TO: Variation 3 Team, City Development

DATE: 4th August 2023

SUBJECT: **3 WATERS COMMENTS ON 2GP VARIATION 3 – MINOR IMPROVEMENTS
CHANGE PROPOSALS**

Table 3: 3W assessment of 3 waters effects from potential residential rezoning sites

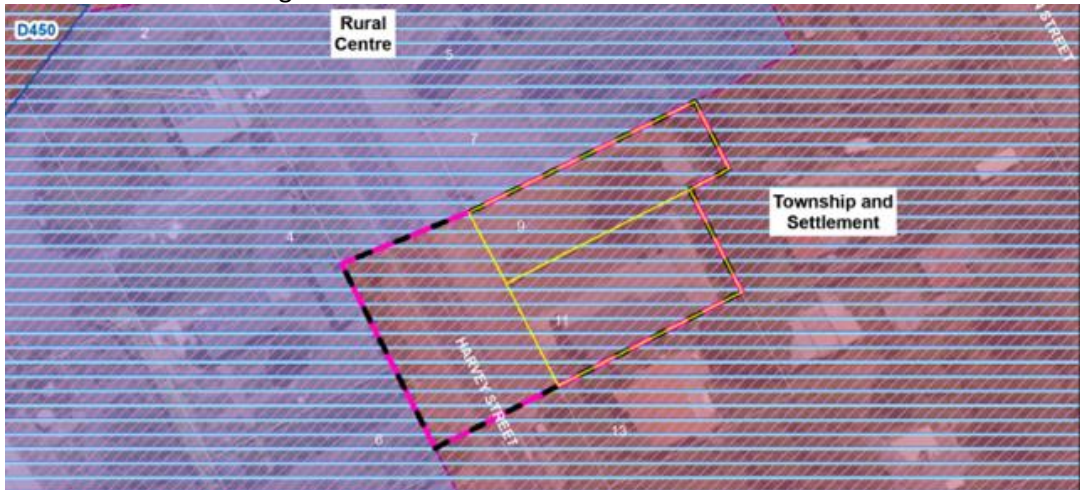
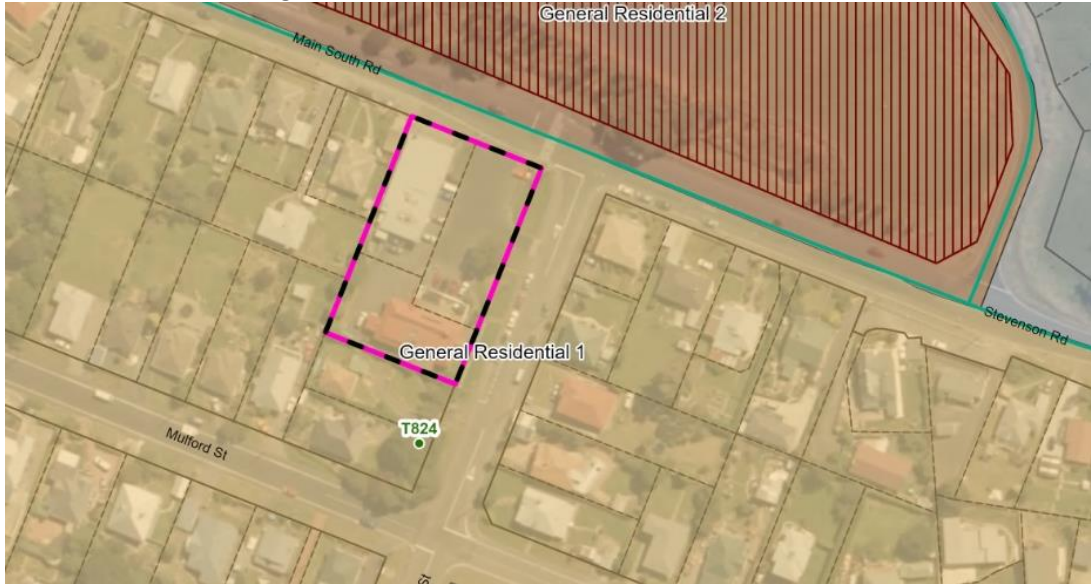
Change ID	Address	Existing zone	Potential zone	Acceptable?	3W Comments
GOING TO RESIDENTIAL ZONES					
Z1	1A and 15 Conway St, Macandrew Bay	Hill Slopes Rural	T&S	Yes 3 Waters would want to see that the riparian planting that has been undertaken by DCC on part of the site is maintained and not removed.	Water Supply - There are known issues meeting water supply demand on the peninsula in summer. However, upgrade projects are in design stage and funding is included in the 2021-31 Ten-Year Plan. The potential impact of the proposal on the water supply network is considered to be minimal and acceptable. Wastewater – there are some issues with the wastewater network in wet weather. The network model lacks detail on the peninsula. The potential impact of the proposal on the wastewater network is considered to be minimal and acceptable. Stormwater - Known downstream issues that have affected MacAndrew Bay School in the past. As part of flood mitigation DCC has undertaken riparian planting on a watercourse running through the site. 3 Waters are comfortable that District Plan Policy and Rules can mitigate any potential impacts of intensification on the site but we would want to see the planting that has been undertaken to be maintained and not removed.

Z7	32-34 Manuka St, 30 Rimu St, part of 11A Matai St, Ravensbourne	Hill Slopes Rural	GR1	No 3 Waters preference is for only: 32 Manuka Street	Water Supply - Moderate upstream network upgrades are required. Given existing use at the site, the potential impact of the proposal on the water supply network is considered to be minimal. Wastewater - there are some issues with the wastewater network in wet weather. The network model lacks detail in West Harbour. While the potential impact of the proposal on the wastewater network is considered to be minimal 3 Waters does not support extension of the GR1 zone into undeveloped areas of the two properties.

Change ID	Address	Existing zone	Potential zone	Acceptable?	3W Comments
				- Part of 34 Manuka Street (Lot 20 Blk II DP 37) to be rezoned. None of: 30 Rimu Street - Part of 11A Matai Street	Stormwater – there are no known or modelled issues in the immediate area however there is modelled flood hazard downstream of the sites. 3 Waters does not support extension of the GR1 zone into undeveloped areas of the two properties.
Z10	4, 12, & 15 Elsie Purnell Place and 56, 58 and 59 Heathfield Drv	GR1/LDR	GR1 or LDR	Yes, with conditions. The following as LDR: 4, 12, 15 Elsie Purnell Place 59 Heathfield Drv The following as GR1: 56, 58 Heathfield Drv	Water Supply - There are known issues due to current supply constraints to Mosgiel in peak summer demand periods. However, upgrade projects are in design stage and funding is included in the 2021-31 Ten-Year Plan. Significant upstream network upgrades required and will be medium term timeframe to resolve. Wastewater - Flows go to Green Island WWTP. Significant downstream network upgrades required as the network and treatment plants have issues in wet weather events. Medium to long term to resolve. Stormwater - The sites currently discharge via DCC piped network into a mixture of DCC open watercourses and private piped watercourses before discharge into ORC Schedule Drains (O5, also known as Quarry Creek) Creek which eventually joins the Owhiro Stream (O Drain) and Taieri River. Quarry Creek and the Owhiro Stream have capacity issues in rainfall events when the Taieri River level is up and the Owhiro can not discharge into it. There are known and significant flooding issues downstream of the sites and concerns from residents at Woodland Avenue, business in the Gladstone Road South Industrial area and East Taieri School. Balancing the zoning similarly to the existing in terms of impervious surfaces, and

<i>Change ID</i>	<i>Address</i>	<i>Existing zone</i>	<i>Potential zone</i>	<i>Acceptable?</i>	<i>3W Comments</i>
					managing stormwater using operative stormwater management rules should ensure that stormwater risks are mitigated.
Z19	1050 Highcliff Road	Peninsula Coast Rural	T&S	Yes	Water Supply - DCC does not provide servicing for water supply in this area. Wastewater - DCC does not provide servicing for wastewater in this area. Stormwater - DCC does not provide servicing for stormwater in this area. As DCC 3 Waters does not provide any services at this location we do not have a strong position on the proposed rezoning. The proposed rezoning seems sensible to align the zoning with the site boundary.
